KIDDERPORE AVENUE • HAMPSTEAD NW3

LISTED BUILDING APPLICATION

SKEEL LIBRARY

DESIGN & ACCESS STATEMENT

Section through roof showing flat rooflight

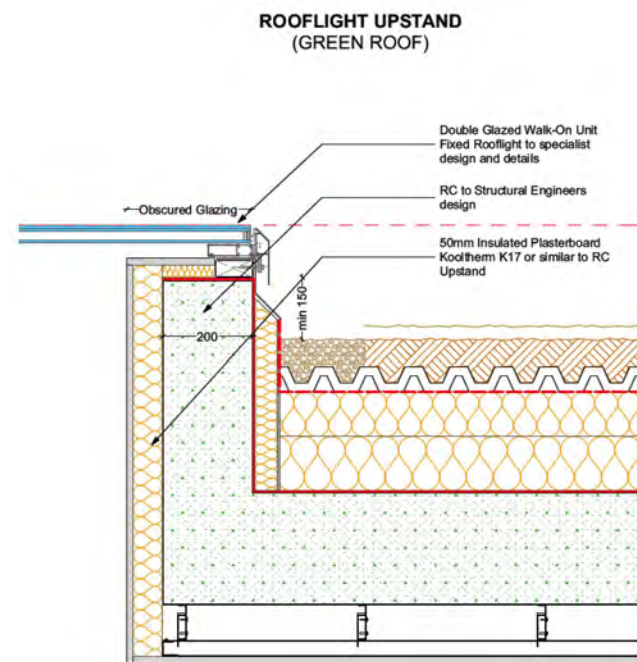
The provision of a central roof light has been retained, in a similar location to the existing and approved designs, but to limit direct overlooking from Maynard Hall, it is proposed to use a flat rooflight, with fritted glass instead of a lantern light. As the roof of this single storey building also provides an emergency escape route from the main building, in the event of a fire, the type of rooflight is suitable for walking over. The rooflight will also incorporate an internal blind for added privacy.

Section through below ground wall drained cavity and insulation

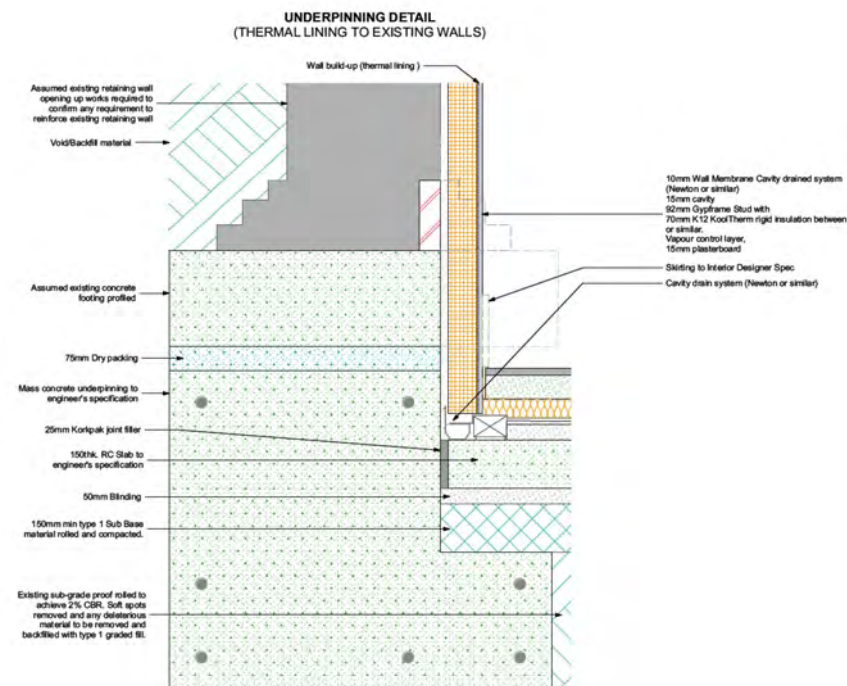
Most of the Lower Ground Floor is partially underground and requires a method of tanking damp proofing and insulation in order to achieve habitable spaces. It is now proposed to achieve this by utilising a drained cavity tanking system, incorporating a Newton or similar membrane and drained cavity. This was not previously identified.

It is now proposed to add thermal insulation is provided by an internal lining to new and existing walls, using Kooltherm rigid insulation or similar supported on a Gypframe or similar stud system.

Extract of proposed new Elevation of single storey extension

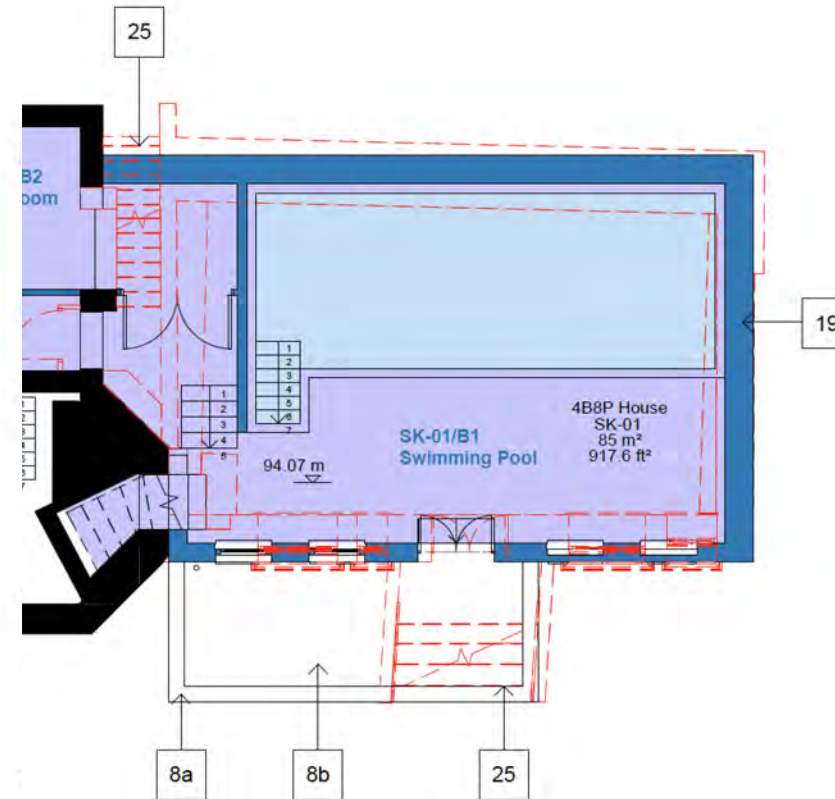
The approved proposals incorporated four windows in addition to the glazed doors facing the courtyard. These proposals reduce the number of windows to two large windows, plus the door, as the submitted proposed elevation.

The external terrace is retained, but the steps are removed, with no access to the central courtyard, with metal railings above the retaining wall as enclosure.

DRAWING
Skeel Library
Level LG Proposed GA Plan

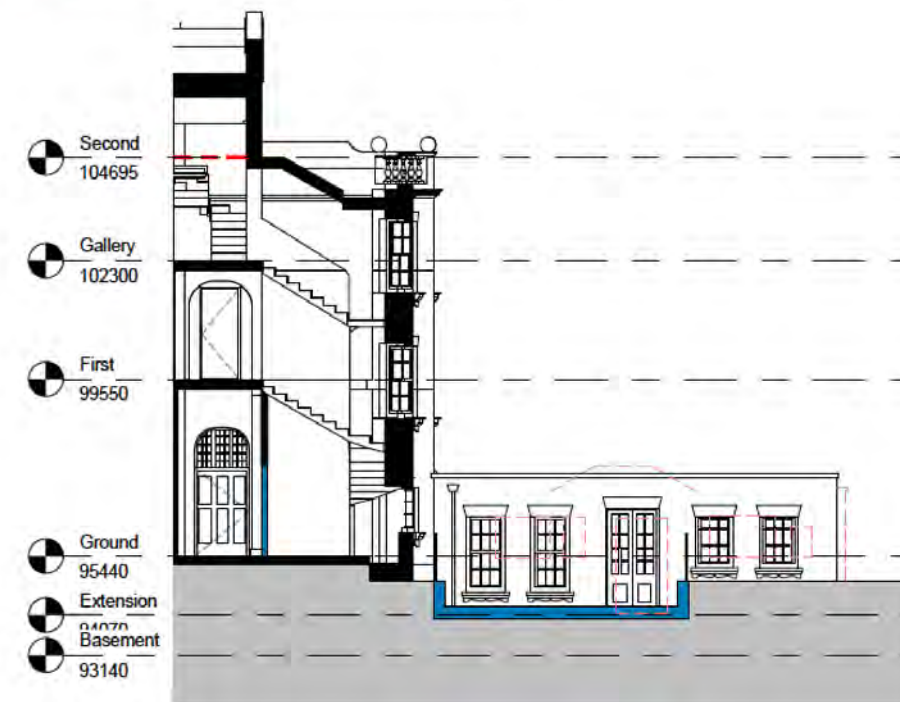
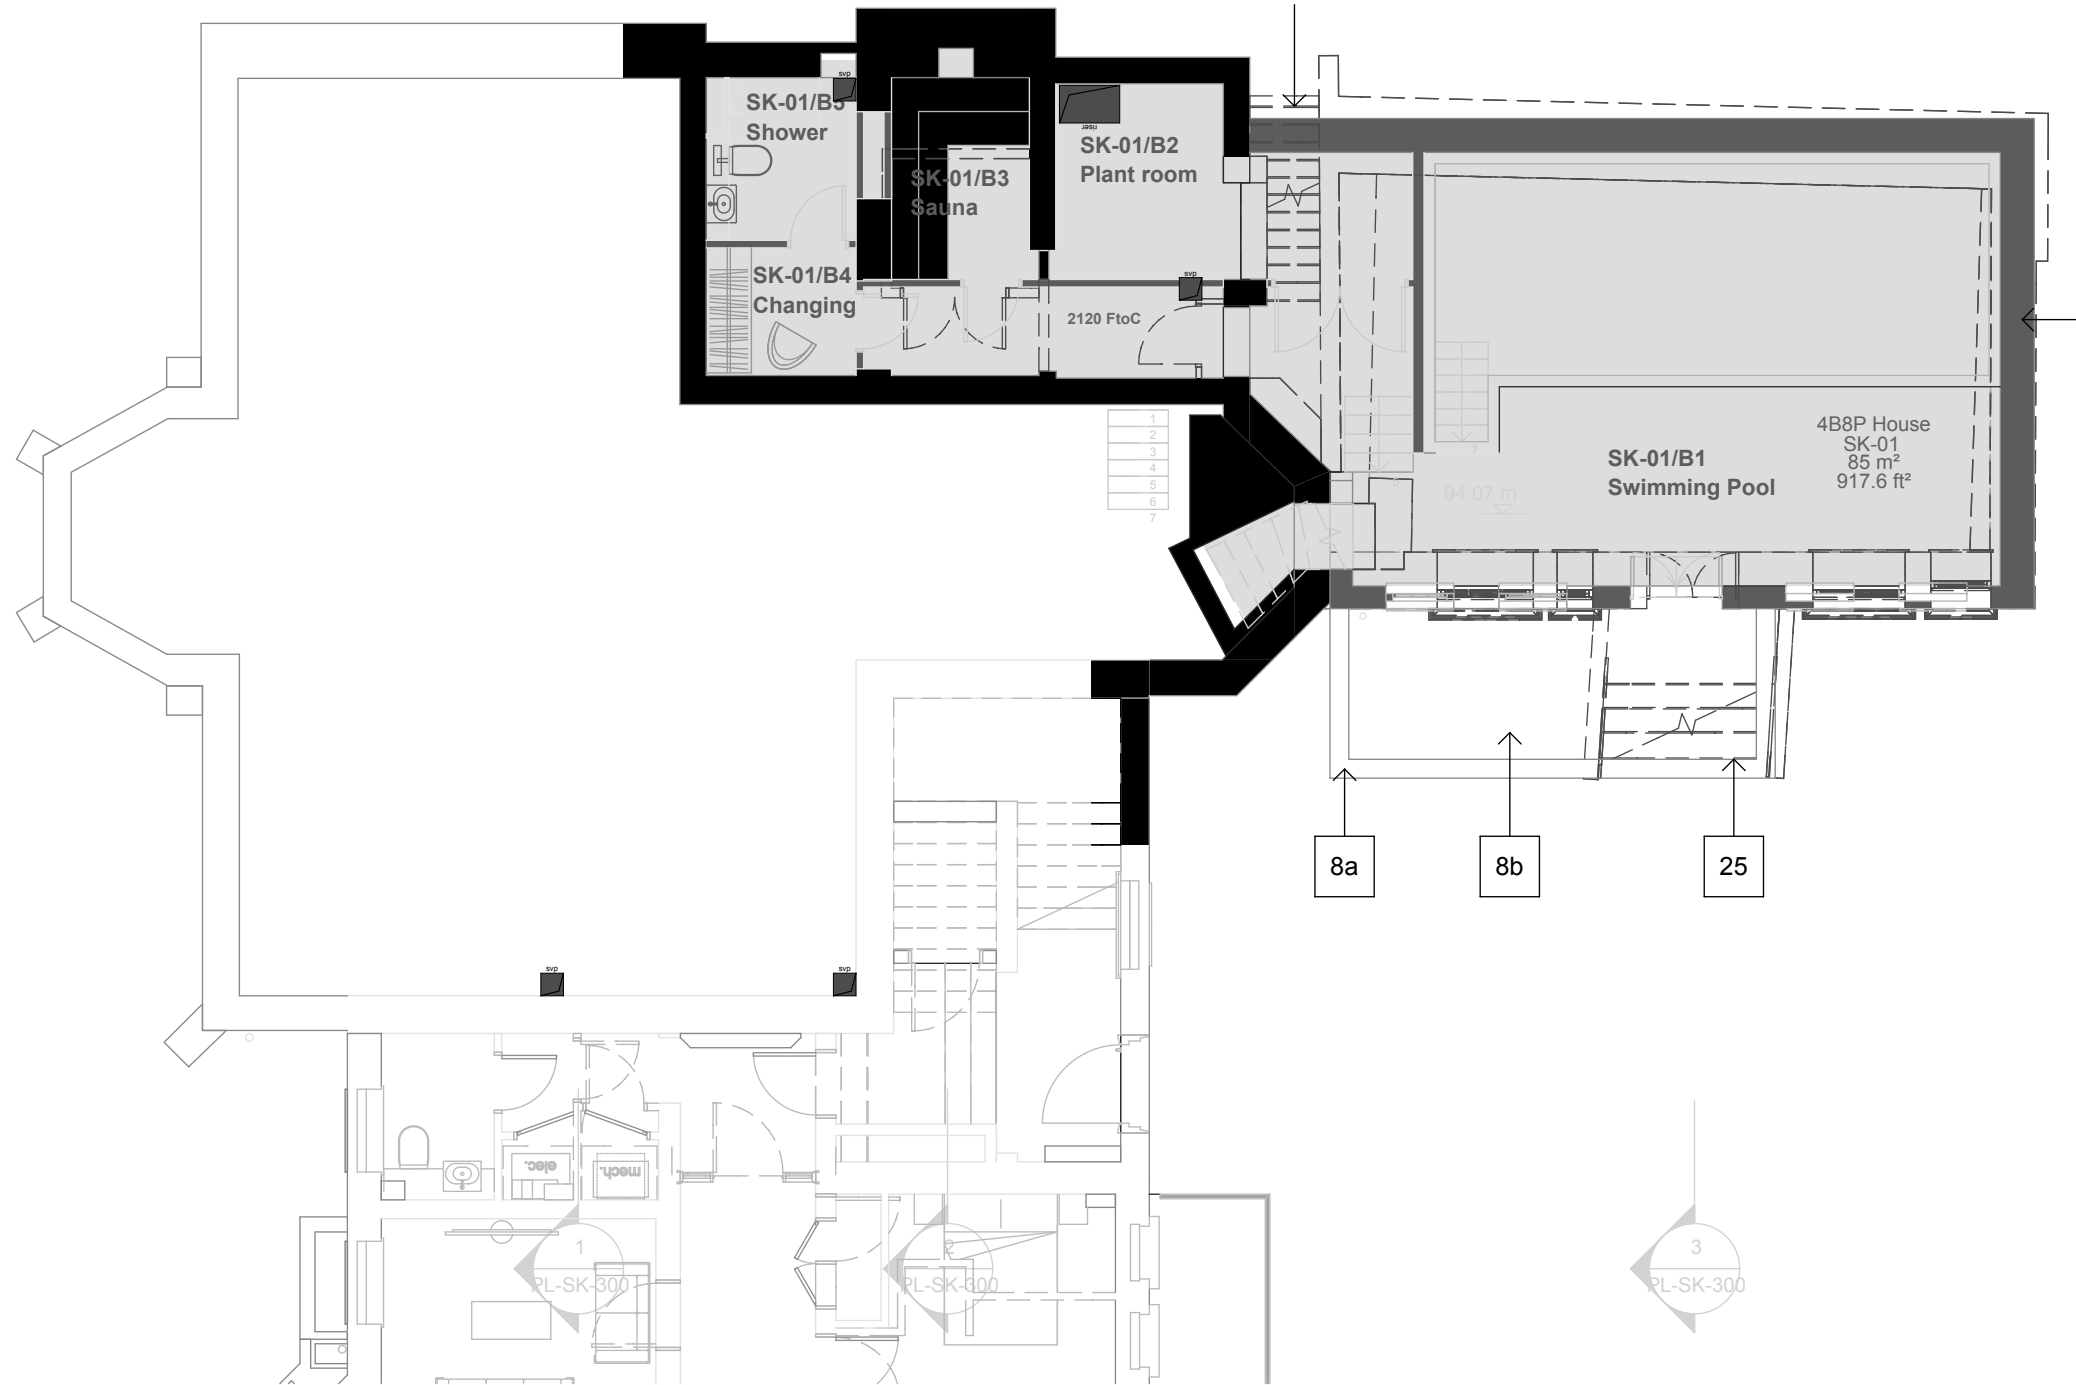
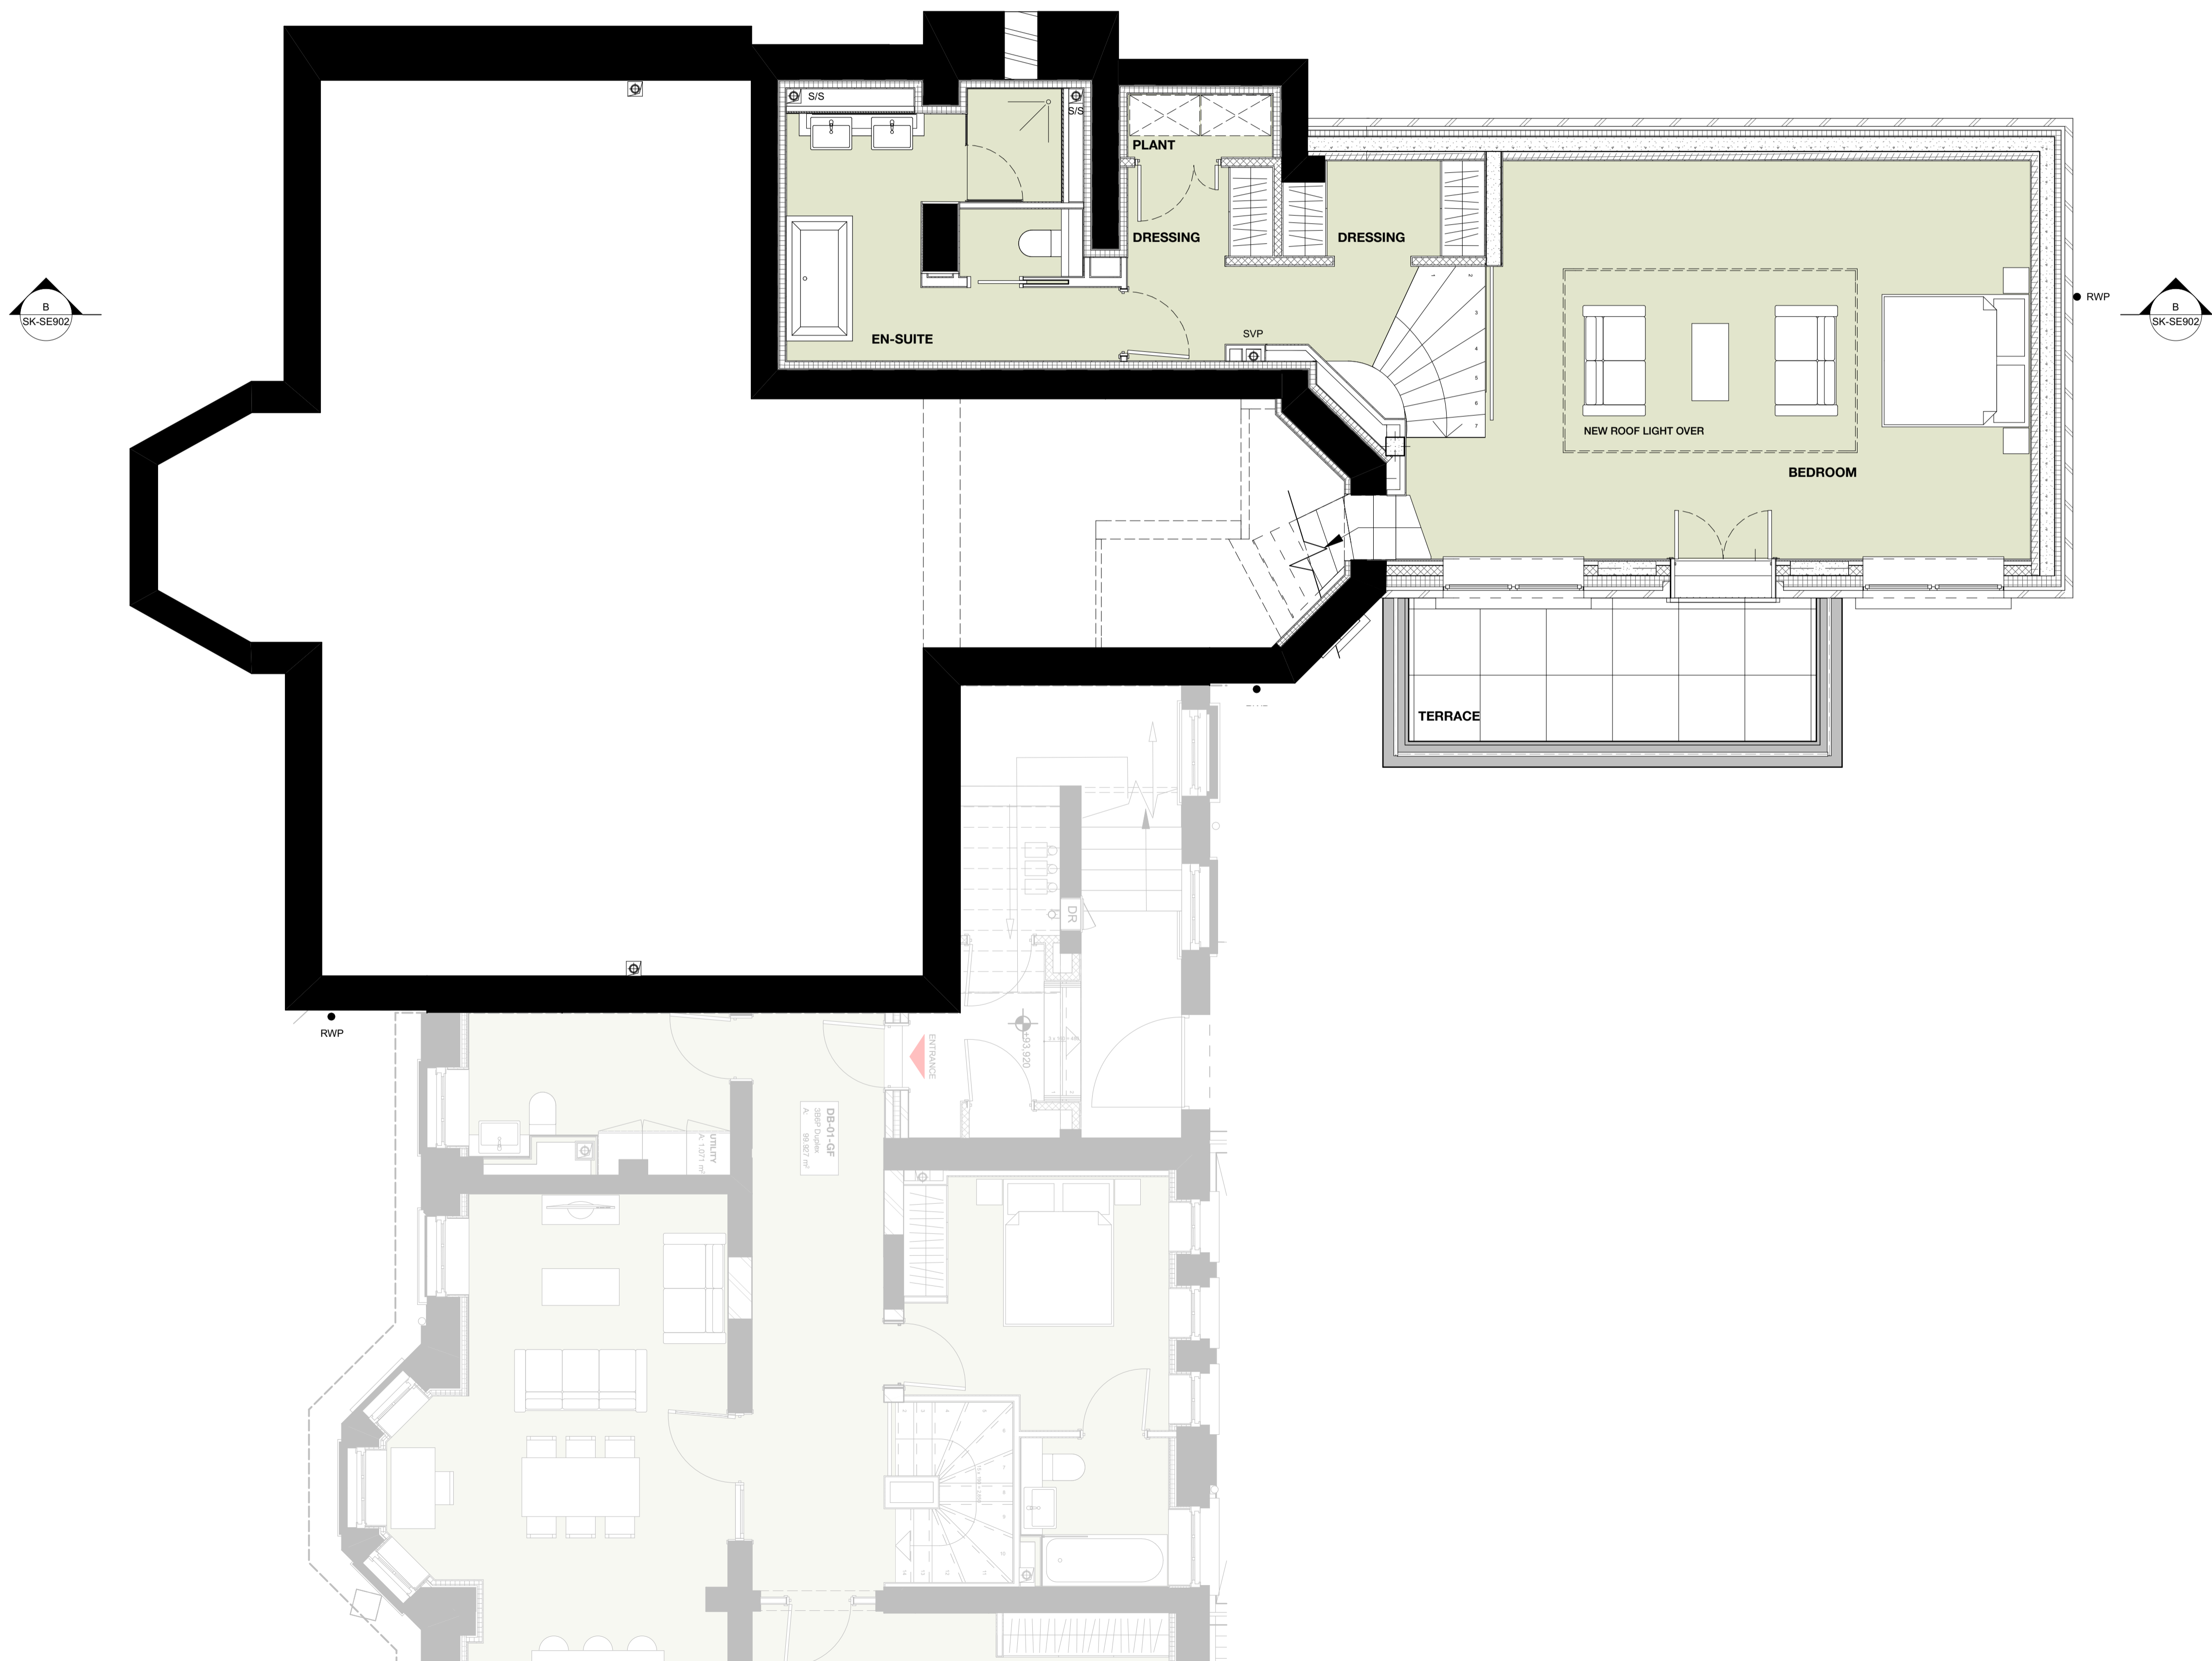
The approved proposals incorporate provision of a swimming pool in the reconstructed single storey extension facing the courtyard.

Following Market research, Mount Anvil have decided that the attraction of including a private pool in such a dwelling, appears to be considerably less than that anticipated at the time of preparing the original application. The decision was subsequently taken to omit this facility and redesign as a guest bedroom suite.

The substitution of a bathroom for the previously approved Sauna, Shower and Changing Room, still utilises the existing basement area, retaining the central brick pier between the two arched openings, which it is now proposed to be retained due to a lowering of the existing floor level to 92.750.

Revision	DRN	CHKD	DATE
- First Issue	KrC	KrC	15/07/2016
A Window and Door Reference Numbers Added	KrC	KrC	28/07/2016
B Gym replaced with Bedroom. Window and Door Reference temporary removed.	Gc	KrC	26/08/2016

Extract of proposed new Section showing Ground Floor Ceiling heights

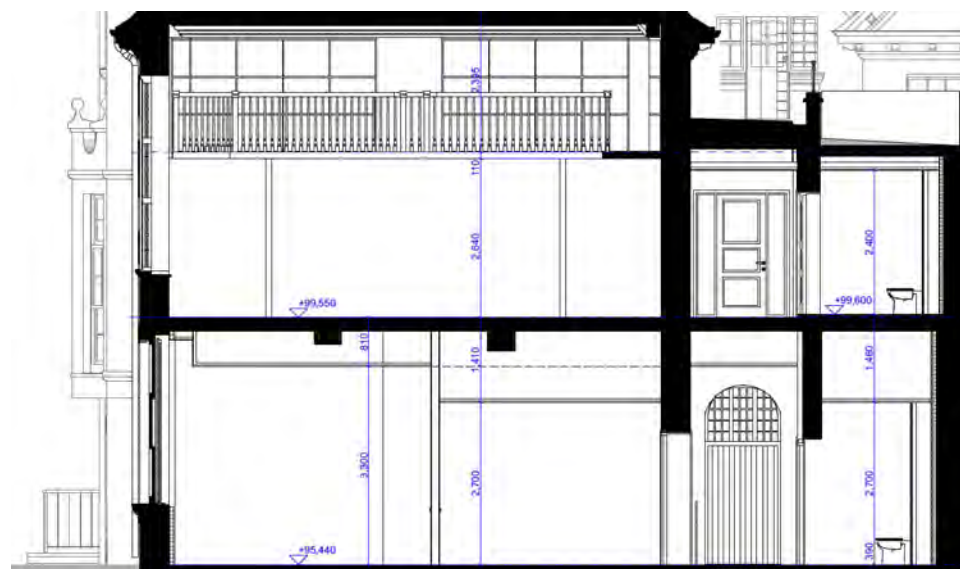
The section indicates the proposals to deal with services within a new suspended ceiling, particularly dealing with the routing of services to the main room above.

It is proposed that the external walls are lined with insulation, as the lower level, with extended window reveal timber linings.

Any work to the floor of the main building at this level does not appear to be defined within the existing consent. This floor consists of timber boards and joists on brick sleeper walls. In order to remove joist bearing ends from damp external walls, provide thermal insulation, the ability to run underfloor heating and deal with the conversion proposals, it is proposed to replace the existing joists and boards with a suspended concrete slab, insulation and screed. An enhanced and adapted timber floor would be less able to provide the necessary performance required.
